### REMARKS

#### Drawing Objections

#### Rejections under 35 USC §103

Fig. 1

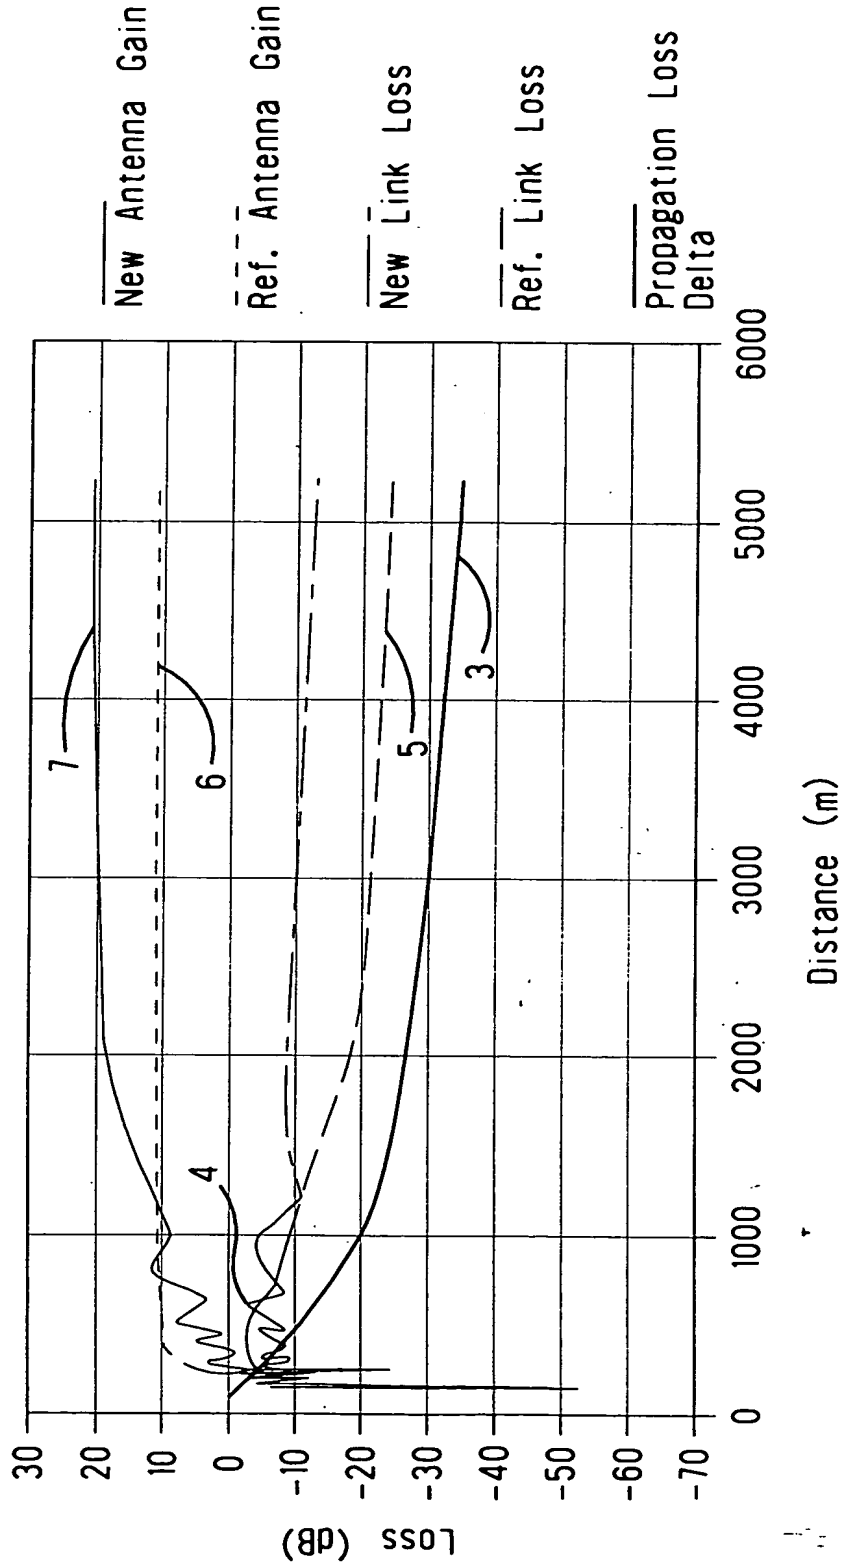
Figure 1 was objected to as having an improper left margin. Applicant assumes that the Office Draftsman meant the top margin, as Figure 1 is oriented in landscape and the left margin, when viewed in landscape, appears to be appropriate.

A new Figure 1 is enclosed which is believed to have the correct margins. Withdrawal of the objection is respectfully solicited.
